Central Subpopulation of Northern Anchovy

STAR Panel Meeting Report

Online
December 7-10, 2021

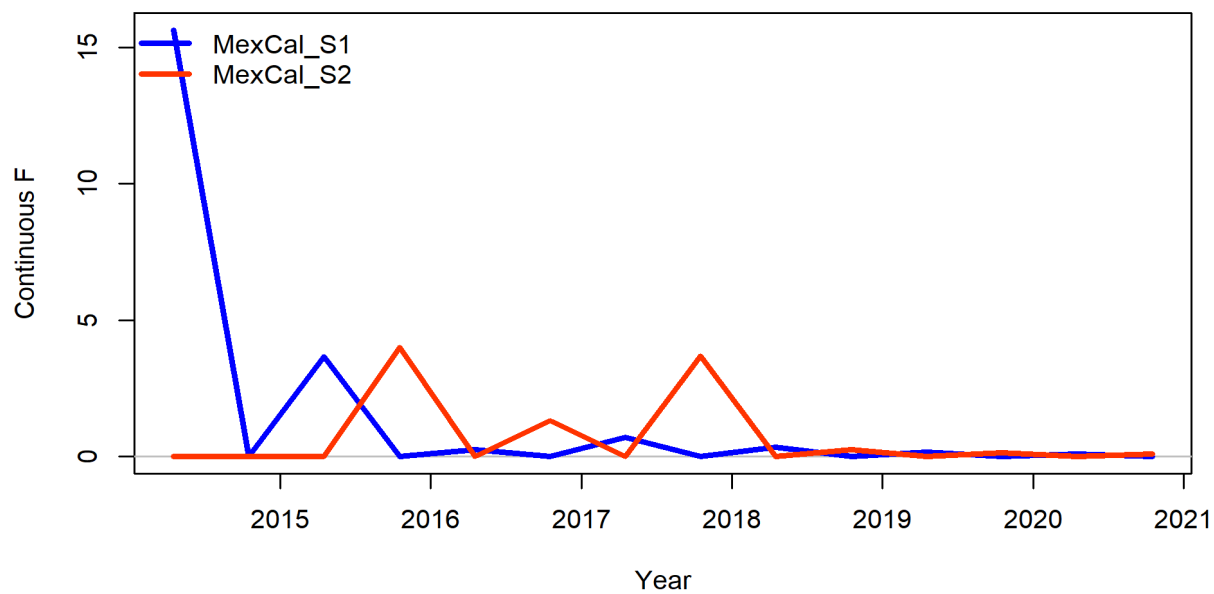
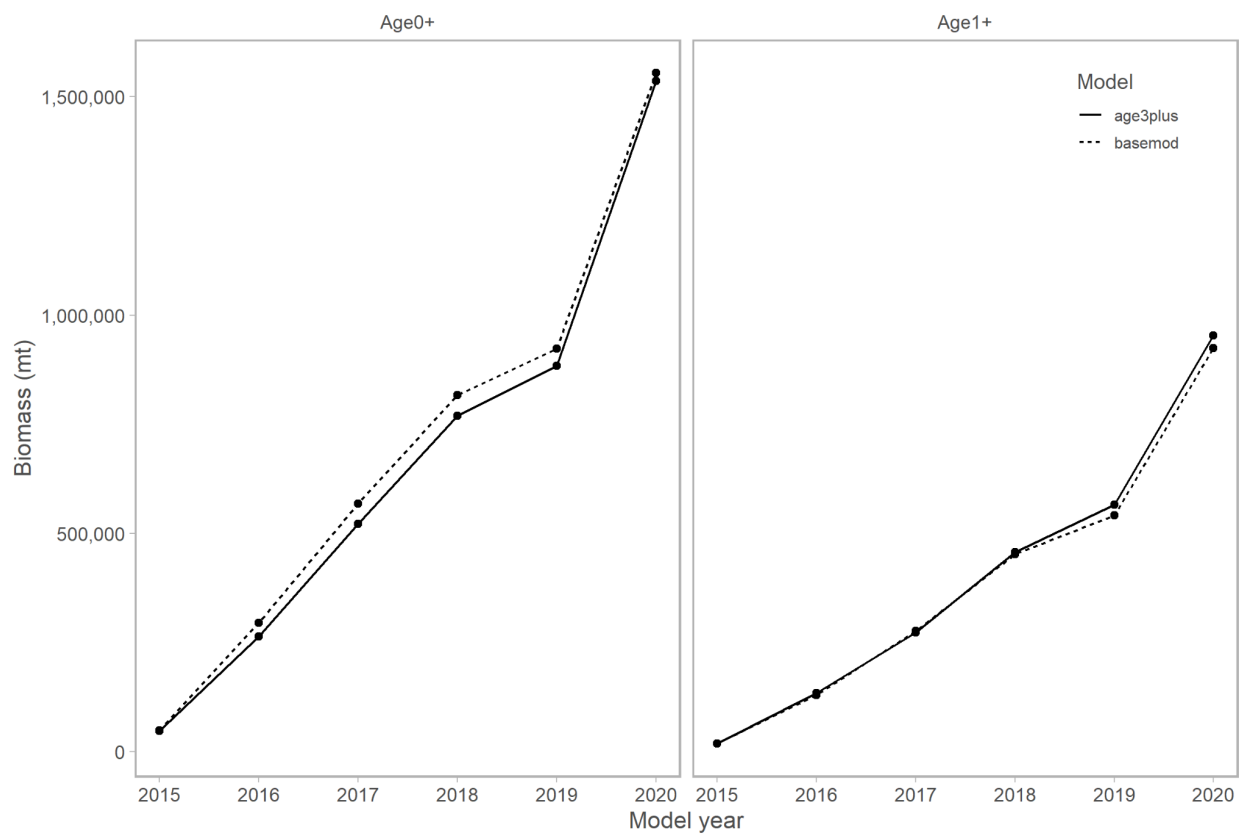
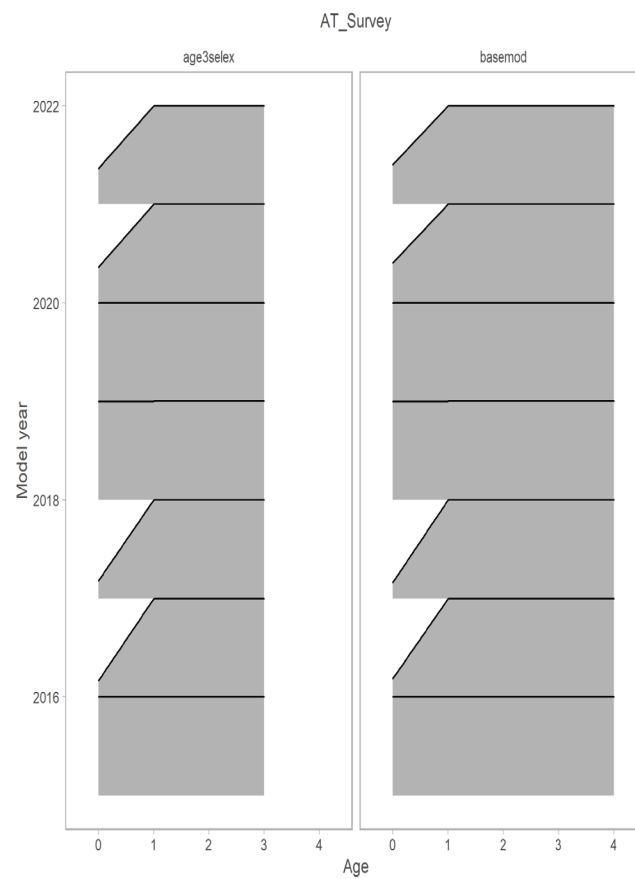
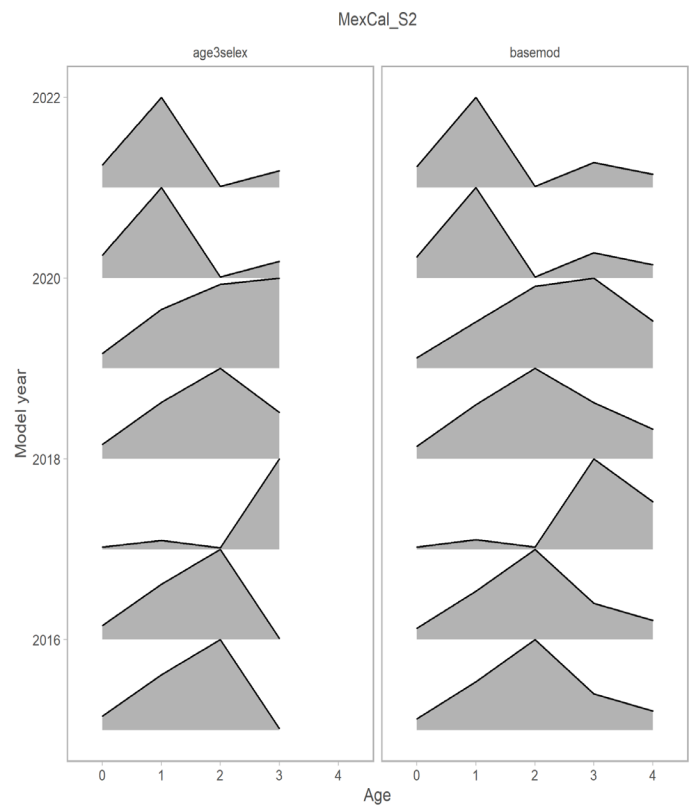
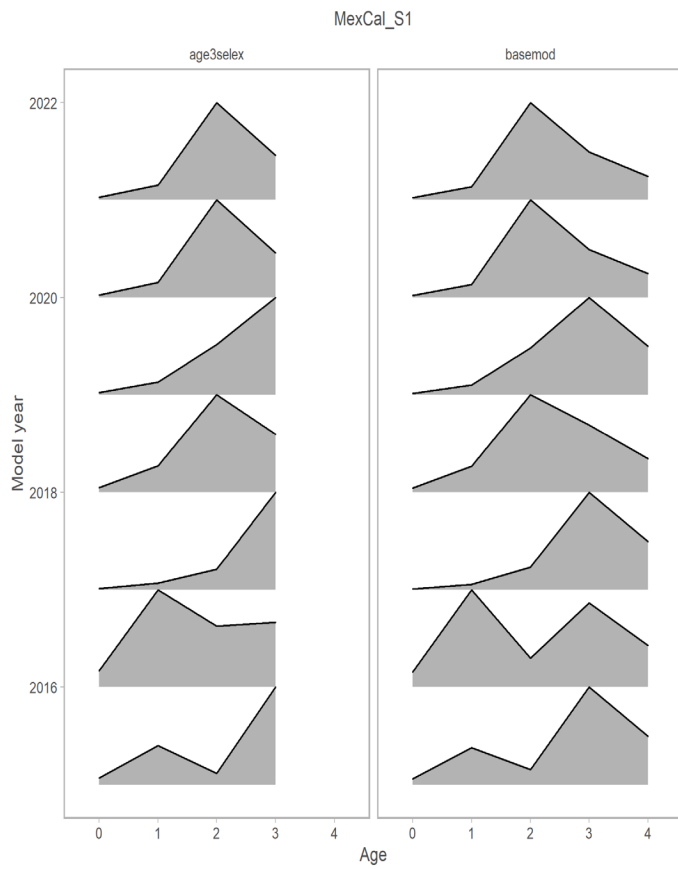
Request 2: As a sensitivity analysis, show the results of starting the plus group at age-3 rather than age-4.

Rationale: There may be little biological difference (e.g., expected length) between age-3 and age-4 fish, ageing errors are greater at the older ages, and age-4 fish appear to be rare.

Response: In the weight-at-age file, the weights-at-age for age-3 and age-4+ fish were combined as a weighted average based on the age-3 and age 4+ values in the age compositions for each fleet. In the age compositions, the age-3 and age-4+ values were summed to one age-3+ value for each year and fleet. The last column of ageing error values was commented out in the dat file and the age-4+ selectivity parameters were removed. The time series comparing age-0+ and age-1+ biomass, selectivity and fully-selected fishing mortality for the two models is shown below.

The Panel noted that the results are insensitive to changing the plus-group age, in particular, pooling age-3 and age-4+ did not result in fewer and less marked time-trajectories of the fully-selected fishing mortality. The STAT agreed to move to a model based on a plus-group at age 3+.

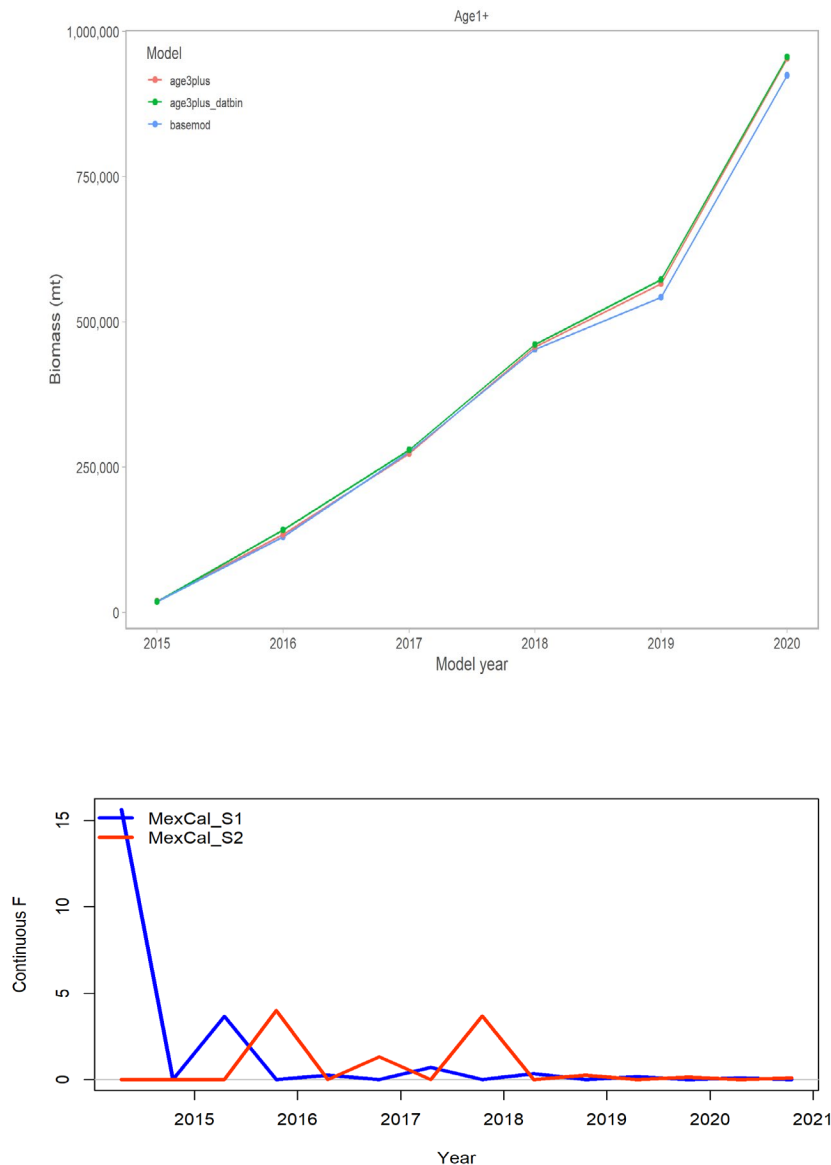
Request 3: Similar to Request 2, but retain a plus-group of age-4+ in the population dynamics model and pool the age-composition data (not weight-at-age data) for age-3 and age-4+ to create a “data plus-group” of age-4+.

Changing the plus-group age for the data but not the population dynamics model had little impact on the results of the assessment.

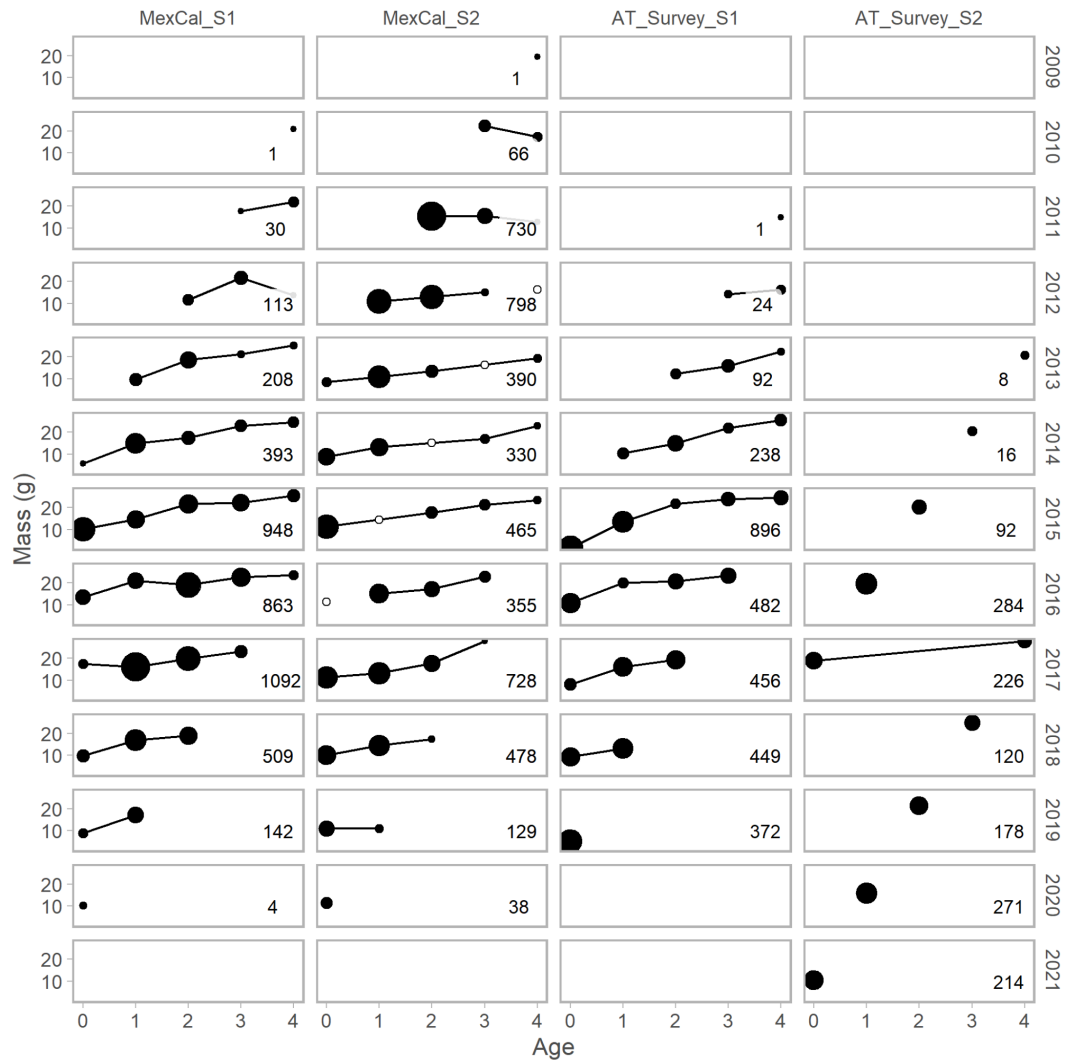
Request 4: Provide more details on the interpolation method used to reconstruct weight-at-age.

Rationale: The interpolation routine was not sufficiently described.

Response: The figure in the draft assessment document is shown below. MexCal_S2 had no data for model year 2016. The age-0 weight-at-age (reference cohort year 2016 on the right side of the plot) was calculated based on the average (mean over all years) of other age-0 fish from the MexCal_S2 fleet. The age-4+ value (reference cohort year 2012) was calculated based on the average age-4+ values for the MexCal_S2 fleet. For the cohorts with missing values (e.g., cohort year 2015; age 1), imputed values were calculated as a linear interpolation between age-0 and age-2 for cohort 2015 under the assumption of linear growth.

The Panel requested that the final assessment document include the description of how the interpolation was conducted.

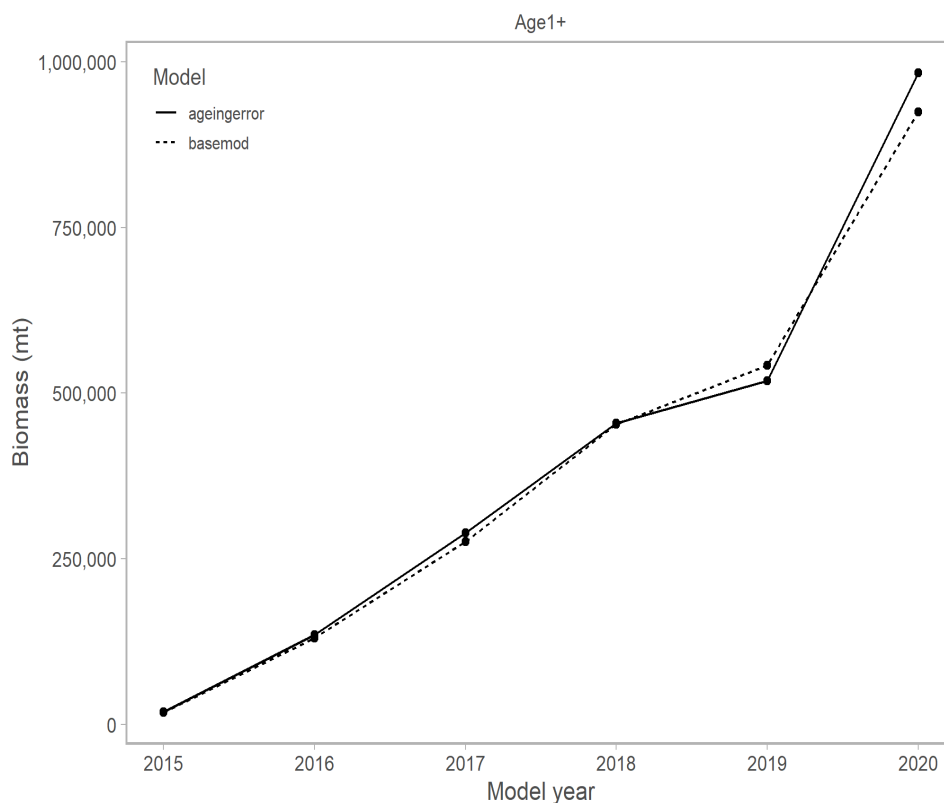
Request 6: Recalculate the age-reading error vectors (for the survey data) to reflect the removal of one reader's outputs from the data included in the assessment, re-run the assessment, and justify the assumption of no bias once that reader is removed.

Rationale: If the data generated by that reader were excluded, their ageing performance is not relevant to ageing error in the age data used in the assessment.

Response: The STAT updated the age-reading matrices excluding the data for “reader 15” from 2017-2021, which led to much smaller (and more realistic) estimates of age-reading standard deviation. A model run based on the updated age-reading error matrices shows little effect of changing the age-reading error matrices on the time-trajectory of age-1+ biomass. Fits to survey and fishery age data were also similar.

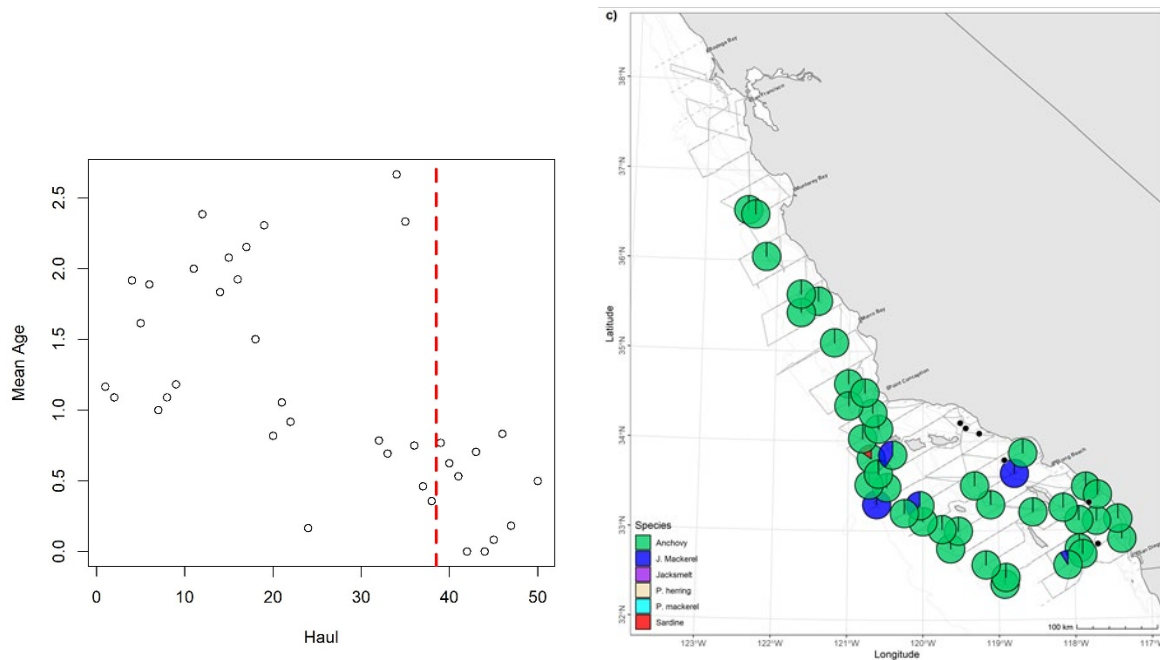
Request 7: Plot mean age by trawl for the Spring 2021 AT survey.

Rationale: It was noted that there was substantial biomass in the north but spawning primarily appeared to have occurred in the south. This could confound calculations of maturity at age/length if age/length compositions vary across space, to an unknown extent.

(Left) mean age per haul from south to north during the spring 2021 AT survey, and (right) haul location. On the left-hand graph, the points to the left of the vertical line correspond to the trawls south of Point Conception. The Panel agreed that the information provided did not necessitate a change to the assessment model but that continued work on understanding maturity was important.

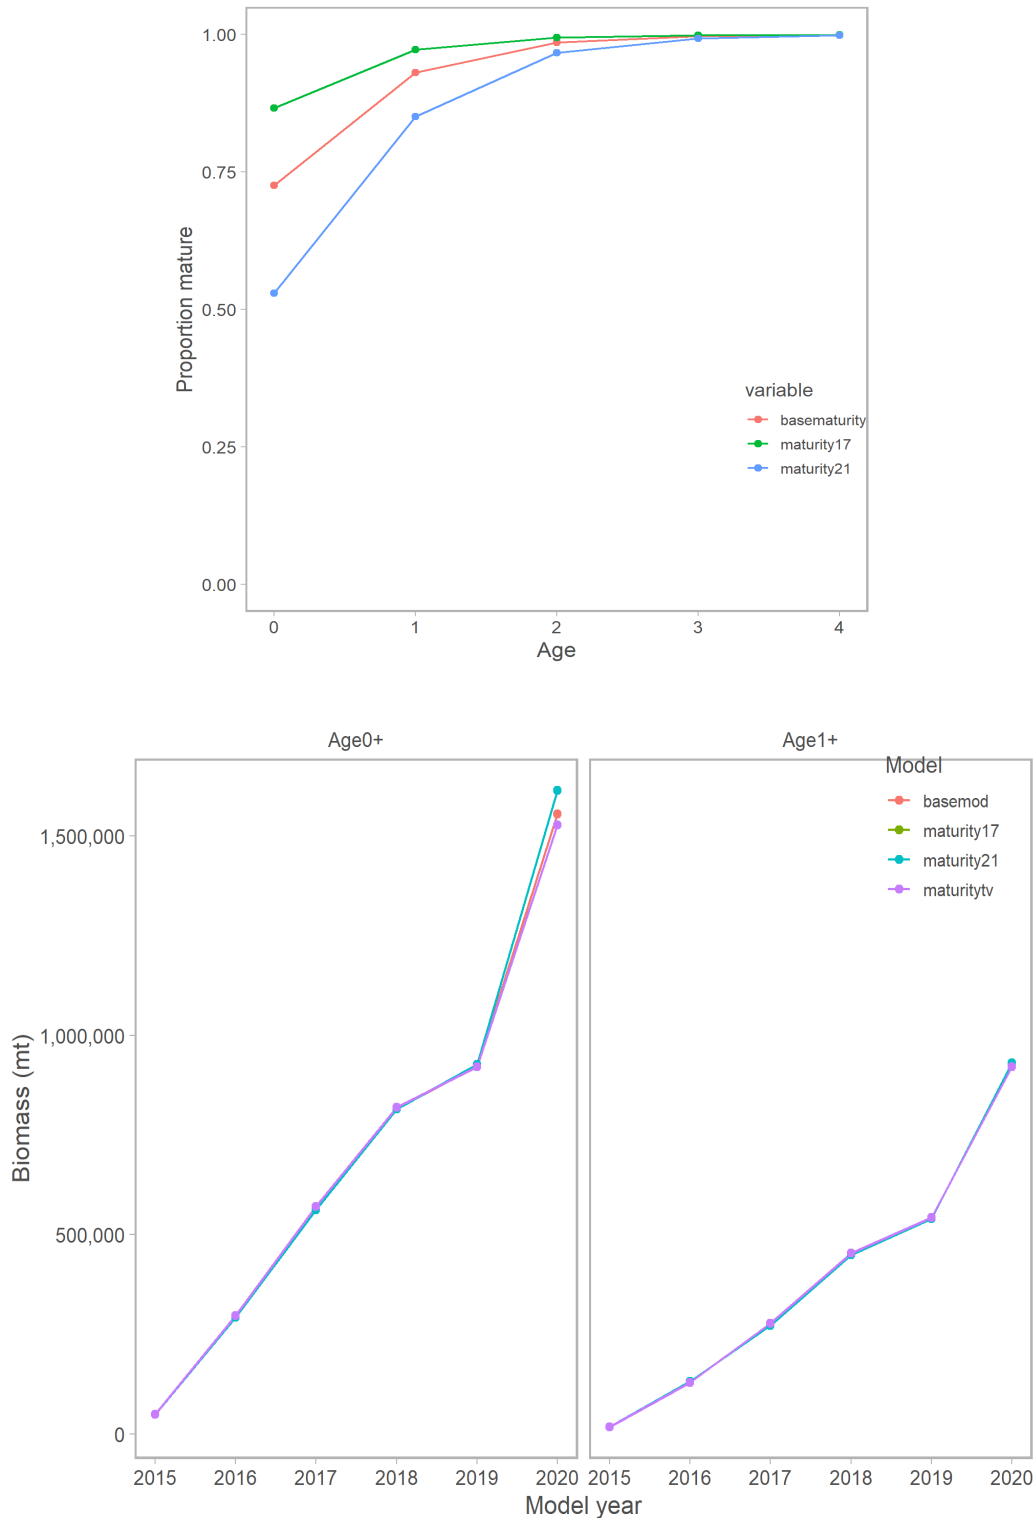
Request 8: Perform a sensitivity analysis to assess how much age-1+ biomass changes if the maturation ogive is based on 2017 data alone or 2021 data alone.

Rationale: The fitted maturation ogives for 2017 and 2021 are different (possibly reflecting density dependence, but with only two years of data this is necessarily speculative) so it is important to determine how sensitive the relevant assessment outputs are to the uncertain maturation rate of age-0 fish.

Response: The figure below shows the maturity curves for only 2017 and only 2021 data compared to that used in the base model and the results of assessment runs using alternative maturity ogives.

The age-0+ and age-1+ biomass trajectories for each of the models are shown above. The figure also includes results for a model (denoted “maturitytv” above) that included the 2017 maturity values for the years 2015-2019 and the spring 2021 maturity values for 2020 (model year) to include the spring 2021 (calendar year; these are equivalent) maturity. The biomass values differ very little among model runs. The Panel agreed that specifications for maturity had little impact on final model outputs used for management. The estimate of E_{MSY} will depend to some extent on

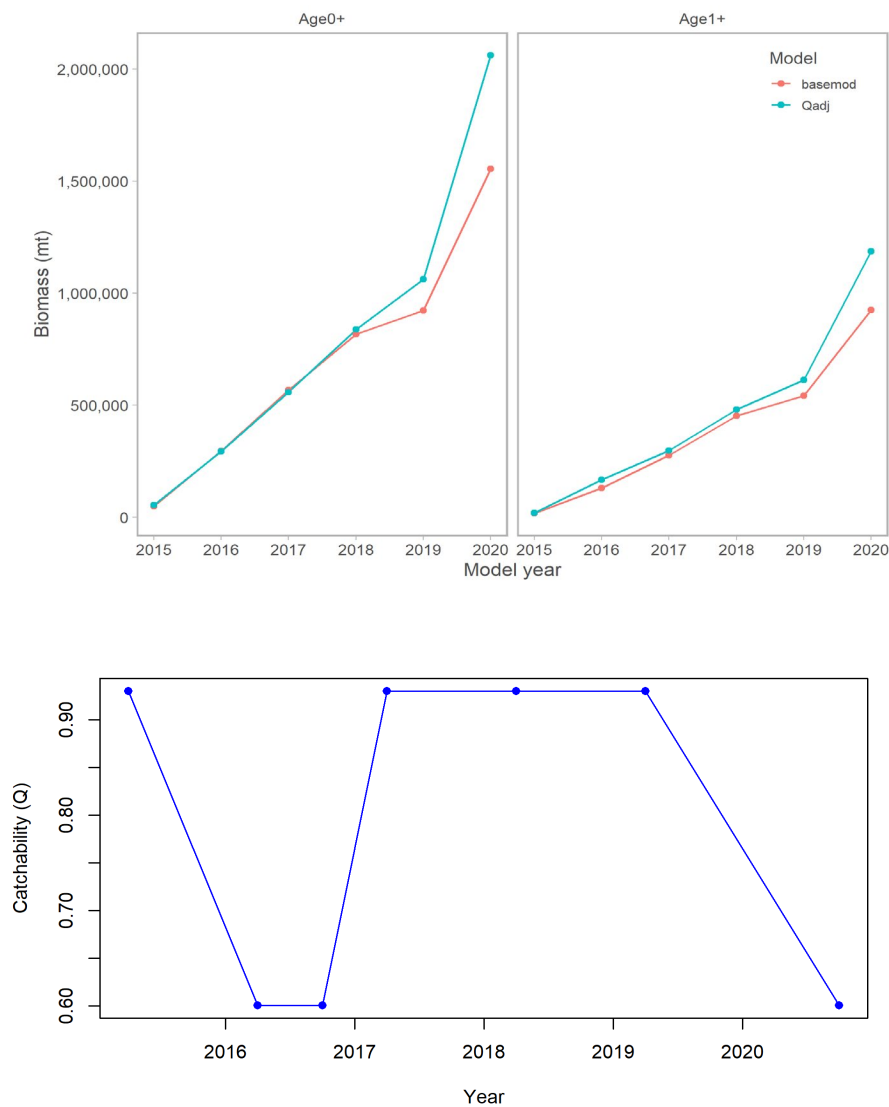
Request 9: As a sensitivity analysis, re-run the base model except with catchability $Q=0.93$ for summer AT surveys and 0.6 for spring AT surveys.

Rationale: In 2021, the summer AT survey extended well into Mexico and presumably encompassed the entire range of CSNA, and estimated a biomass of 2,357,317 mt (out of which 168,626 mt or 7% was in Mexico). The spring 2021 AT survey stopped at the US-Mexico border and estimated a biomass of 1,358,587 mt. Assuming no change in total biomass between spring and summer, this suggests that only a fraction ($1,358,587/2,357,317 = 0.58$) was in US waters in the spring (rounded to 0.6 for the initial request). In the summer 2021 AT survey, 93% of the estimated biomass was in the US.

Response: The STAT conducted an initial analysis in which survey Q was 0.93 for summer AT surveys but survey Q for 2016 was 0.6 for both surveys.
